Modification Recommended Service Note

P5007A Keysight Streamline USB Vector Network Analyzer

Potential lifted front panel overlay

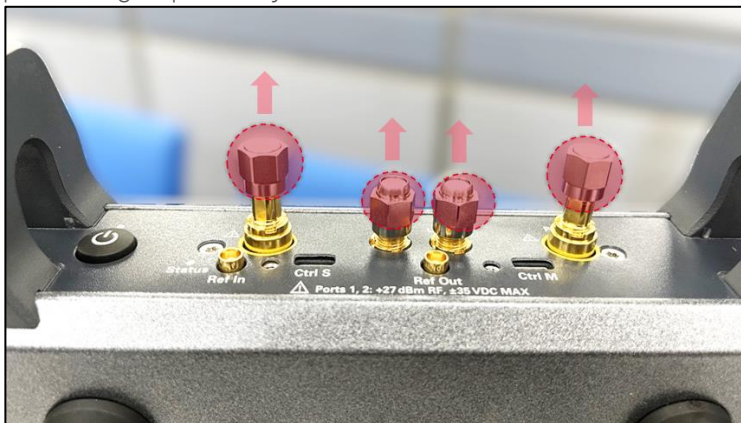
Keysight streamline series vector network analyzer (VNA) of serial number range identified in service note cover page might potentially exhibit the following lifted front panel overlay symptom.

Apart from cosmetic imperfections, the lifted front overlay could have led to non-fully attached *Ctrl S* micro-HDMI cable connector in multi-VNAs setup configuration.

-> Apply this service note only if end users' VNA is exhibiting the following symptom.

Procedure to replace the front panel overlay.

1. Remove the front handles. Detach the 50-ohm termination (LO-In, LO-Out, Port 1 & Port 2) or protecting caps if they are attached to the VNA.

2. Pry open the existing front panel overlay and remove it from front panel.
3. Clean the metal surface thoroughly and ensure it is free of adhesive residue.
4. Affix the new self-adhesive front panel overlay onto the metal surface.
5. Reinstall (reuse) the 50-ohm terminations or protecting caps accordingly.

6. Reinstall (reuse) the front handles.
